AMENDMENT NO. 1 JANUARY 2024
TO
IS 15500 (PART 1 TO 8) : 2021 DEEPWELL HANDPUMPS, COMPONENTS AND
SPECIAL TOOLS — SPECIFICATION

(First Revision)

FIG. 2.2 DEEPWELL HANDPUMP - VLOM 65

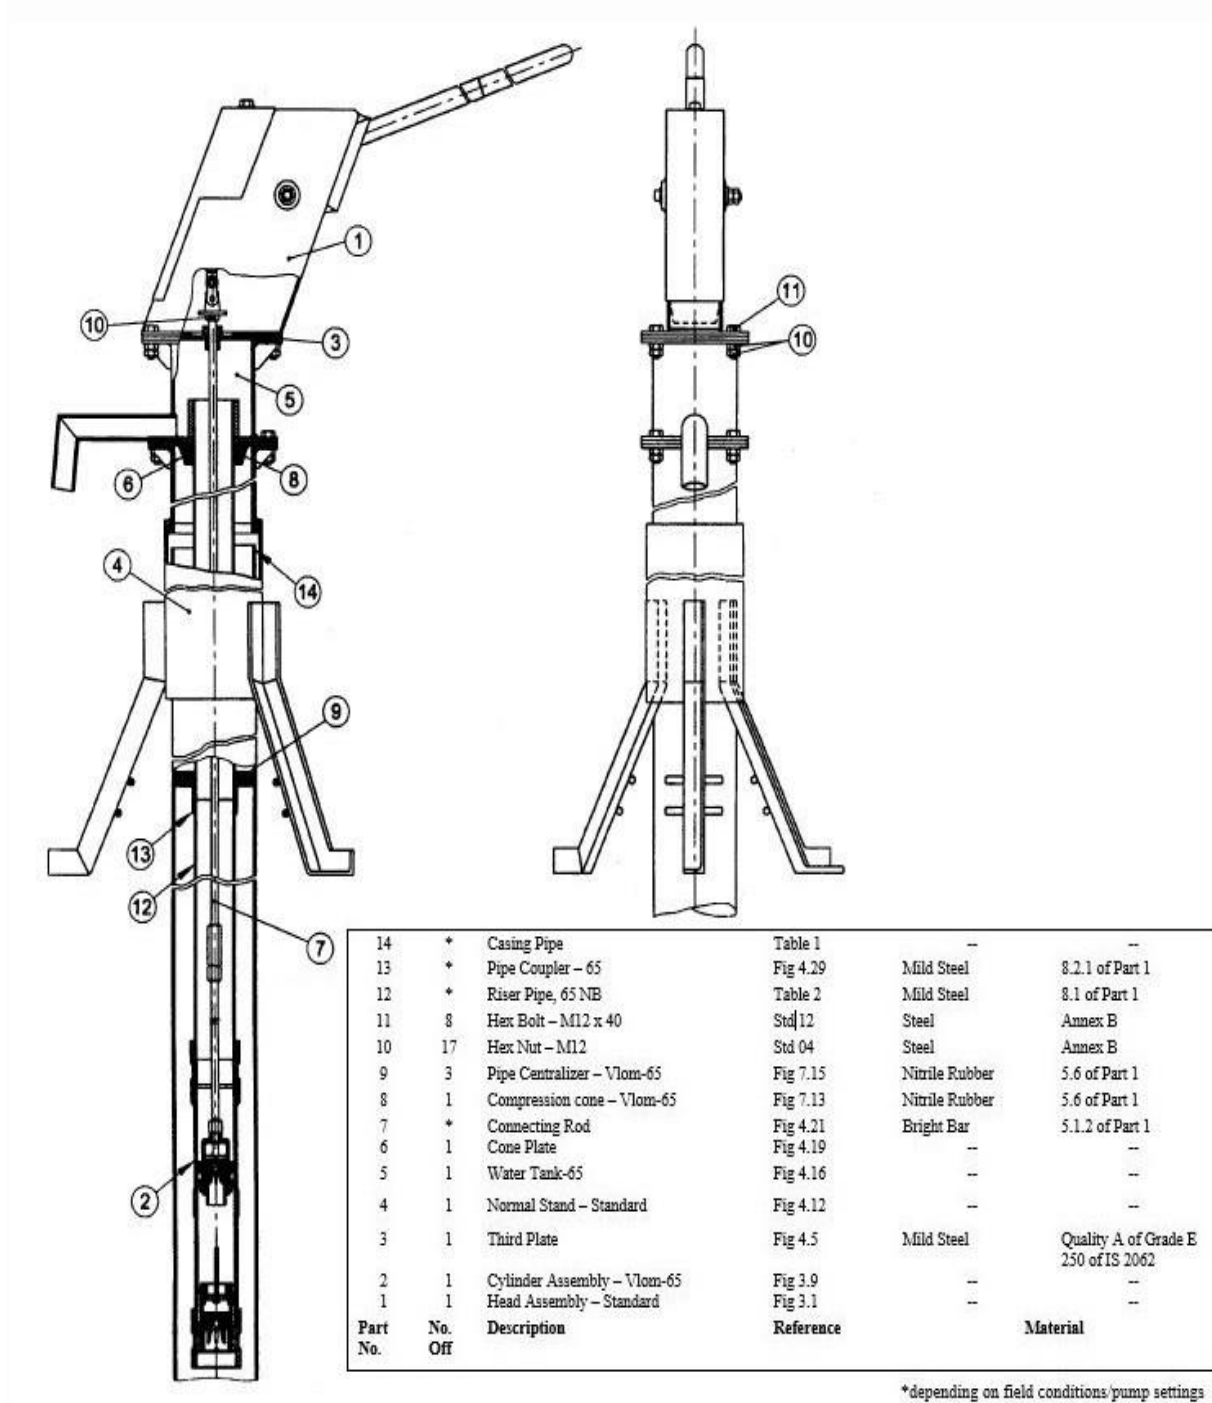
(Part 2, Page 11, Fig. 2.2) — Substitute the existing figure and table with below given figure:

FIG. 5.5 CYLINDER CAPS - VLOM 65

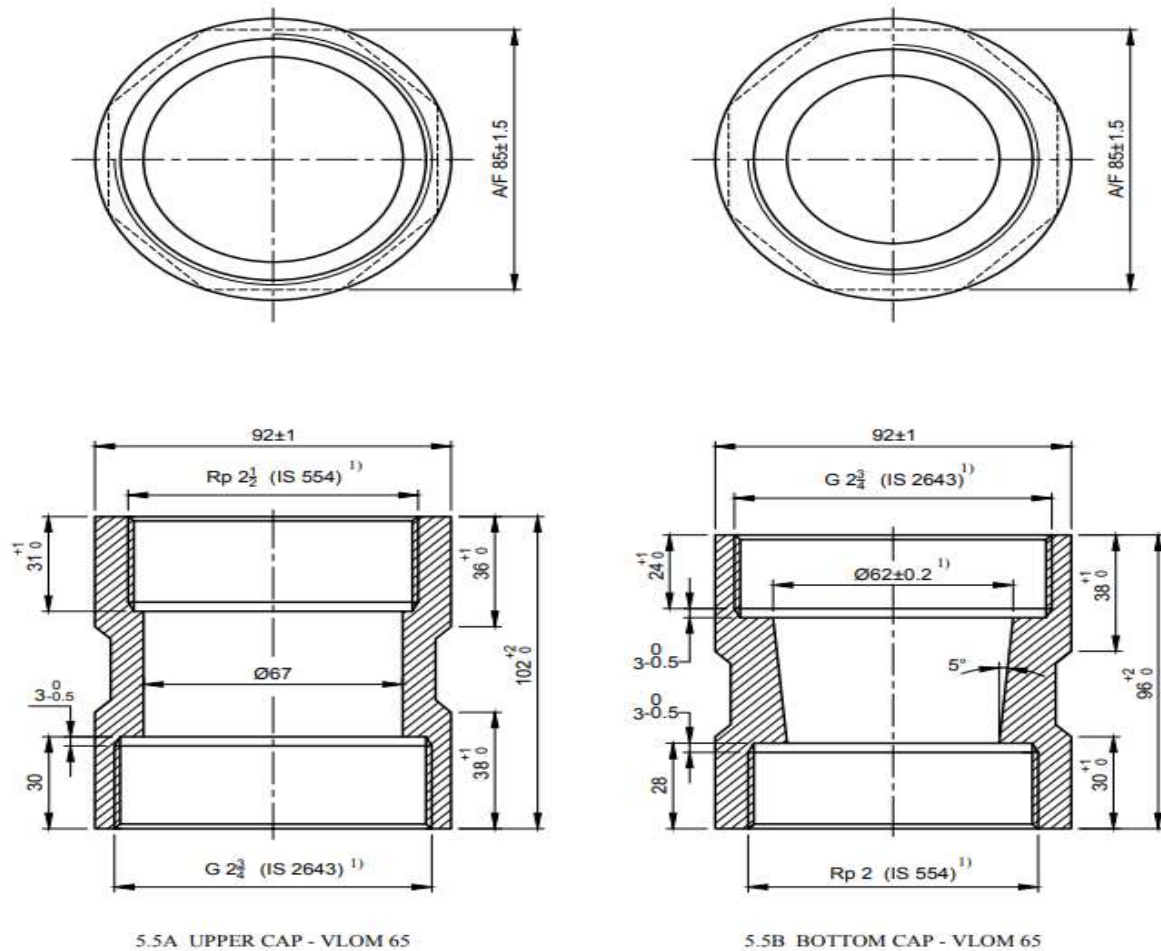
(Part 5, Page 64, Fig. 5.5) — Substitute the existing figure with below given figure:

¹⁾ Indicates critical dimensions

All dimensions in millimetres.
